North Focus Area

Public Comments N. 110th Street to N. 145th Street

An Overview of Public Comments

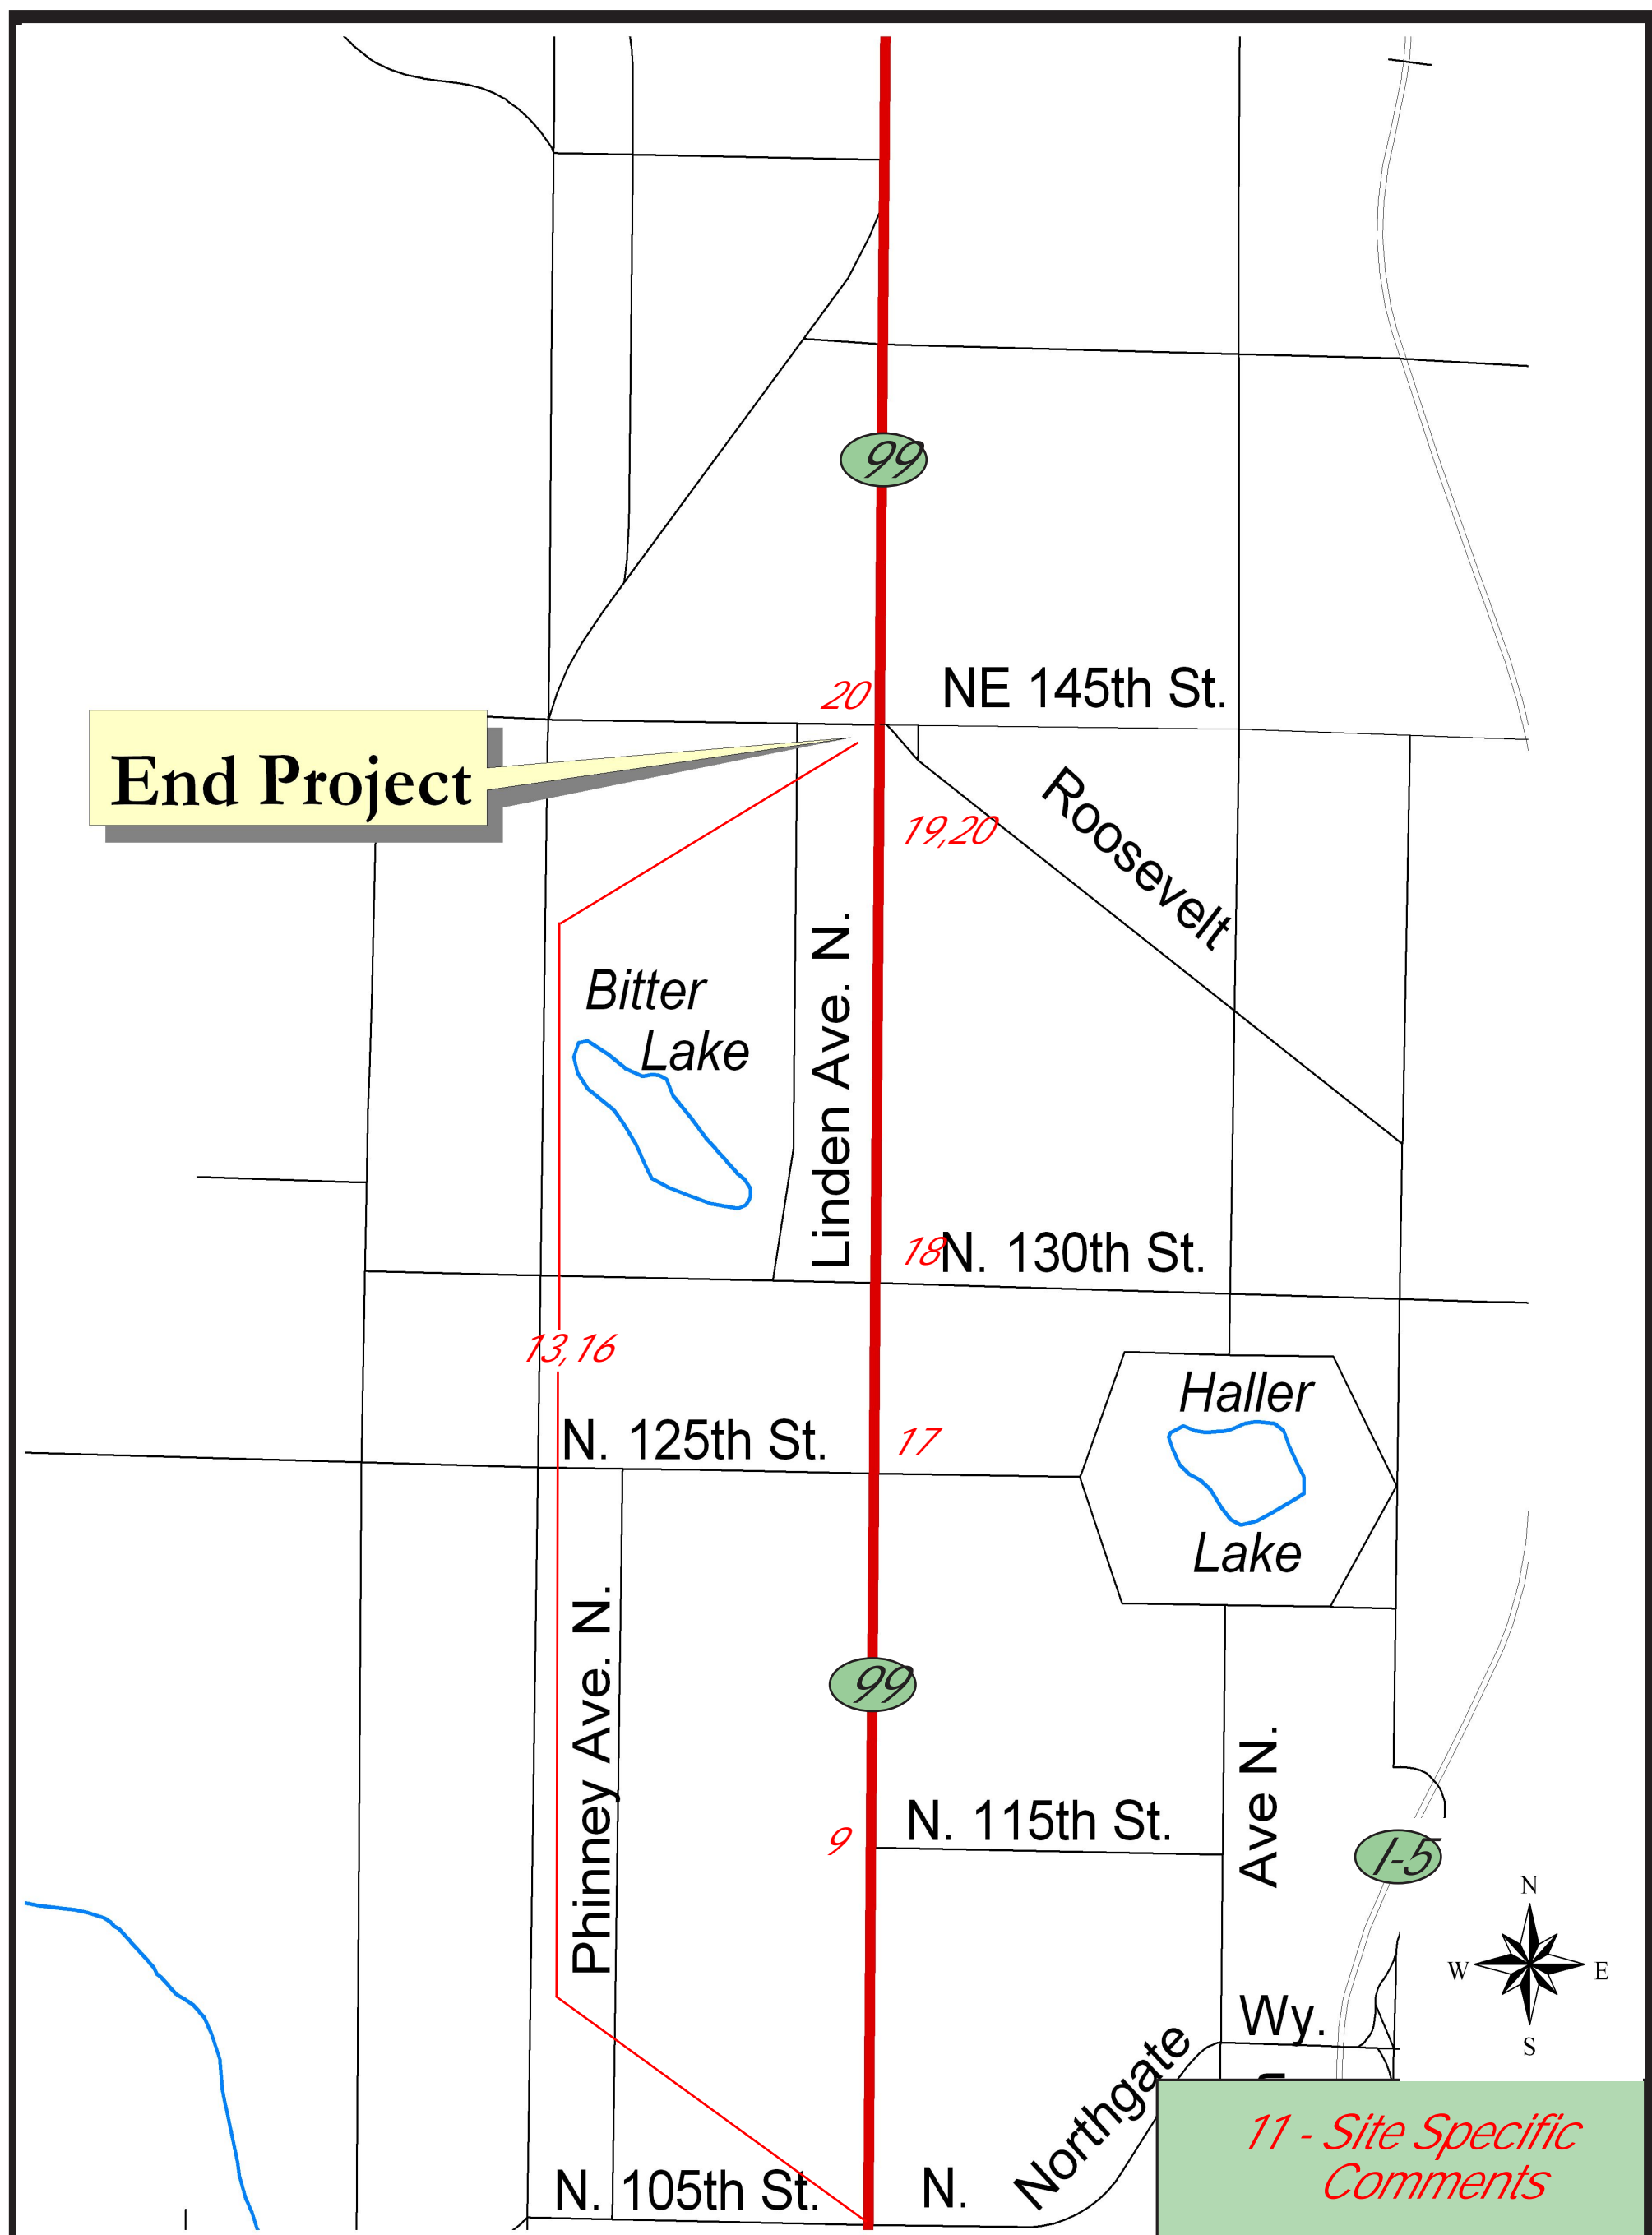
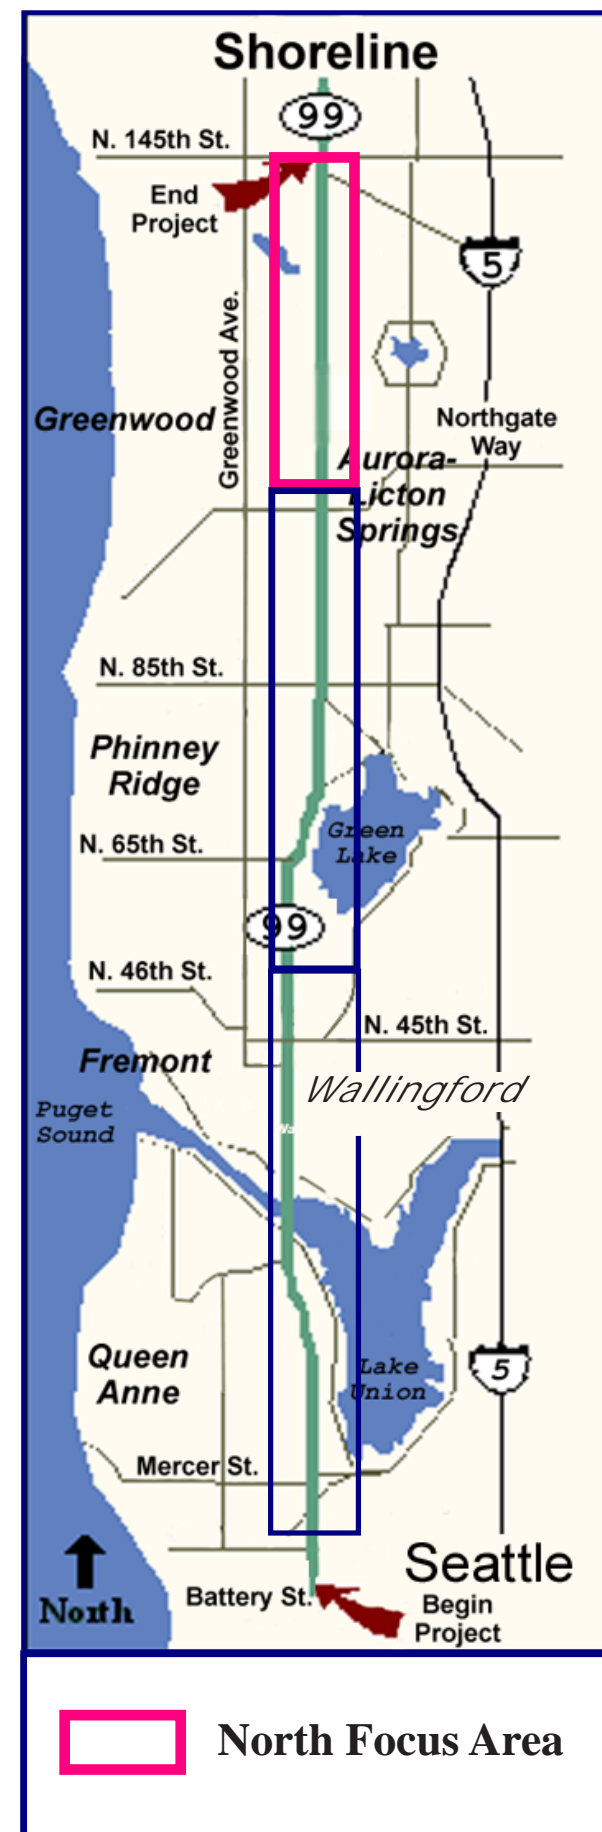
1. Space business accesses at 50 feet
2. Eliminate driveways where possible, especially if there is access through a side street (i.e. PCC Market and Oak Tree)
3. Maintain on-street business parking
4. Eliminate all parking along Aurora/SR 99, especially when service falls below LOS C
5. Look at work done in SeaTac, Des Moines—limiting two-way left-turns, sidewalks, focusing business access
6. Look into the possibility of U-Turns in this section of SR 99
7. Keep the current dedicated two-way left-turn lanes
8. Limit left-turn lanes along SR 99 to existing signalized intersections
9. Connect the Home Depot driveway to N. 115th St.

10. Add low profile vegetation in medians
11. Keep center median open for turning vehicles
12. Center turn-lane is a real problem
13. Install median planting strips from N. 105th Street to N. 145th Street
14. Raise Jersey barrier where it exists by two feet so no one will want to climb over it.

15. Improve speed and reliability of transit service

16. Install concrete curbs and curb ramps between N. 115th St. to N. 145th St.
17. Lengthen the pedestrian crossing times at N. 125th St.
18. The N. 130th St. overcrossing is not being used. Provide illuminated signage and shrubbery to direct pedestrians to identified crossings

19. Add a pedestrian activated signal at N. 140th St.
20. Look at possible underpass-overpass locations at N. 140th St. and N. 145th St.
21. Need pedestrian activated signals

22. Limit pedestrian crossings to one per five-block segment, and if possible, provide an underpass instead
23. Bicycle facilities along SR 99 should be limited considering the proximity to the Interurban right of way and traffic speed

25. Add sidewalks that conform to the existing ones
26. Bring walkways up to code
27. Establish sidewalk-width guidelines with developers so there is width continuity between new sidewalks and old sidewalks
28. Address sidewalk issues
29. Correct sloping driveway aprons so that sidewalk users can maintain level ground
30. Install sidewalks, curbs, and gutters along the entire length of Aurora
31. Build out sidewalks as right-of way permits

32. Support education and law enforcement activities that reduce alcohol consumption
33. Landscaping should be low-growing shrubbery
34. Consider installing low-pressure sodium lights to discourage prostitution
35. Consider motion sensor sprinkler systems and/or sporadic sprinklers
36. Look at location of drinking establishments in relation to High Accident Locations.
37. Improve signal phasing and turning movements
38. Provide more law enforcement
39. Don't focus on traffic calming; speeds should be maintained at 50 mph

40. Do not support bus-only lanes if converting them from general-purpose lanes

41. Allowance for some property-side landscaping only
42. Make sure improvements don't cause traffic to move onto residential streets
43. Concerned about this study paralleling the Shoreline Study
44. Consider raising the corridor and putting retail businesses underneath
45. Make sure project improvements meet the American's with Disabilities Act (ADA) guidelines
46. Need for logical re-development
47. Placement of street furniture should be at the discretion of property owners
